21/0007/LRB (Planning Ref: 20/02264/PP) – Land South West of Letrualt Farmhouse, Letrualt Farm Lane, Rhu

To provide a copy of the roads usage assessment or provide further information in terms of how the assessment of the proposal was reached against Policy SG LDP TRAN 4

Forward Visibility at Bend in Road

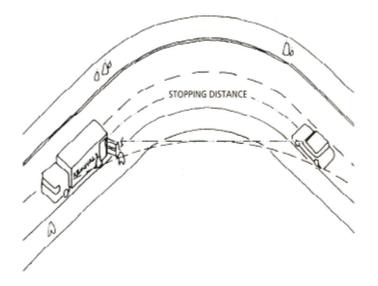
The forwards visibility in accordance with the National Roads Development Guidance cannot be achieved due to the existing geographical constraints.

The lack of forward visibility has highlighted the requirement for localised widen of 5.5m at points of Intervisibility. In the interest of road safety, to allow any further development on this private access road, intervisible passing places must be provided.
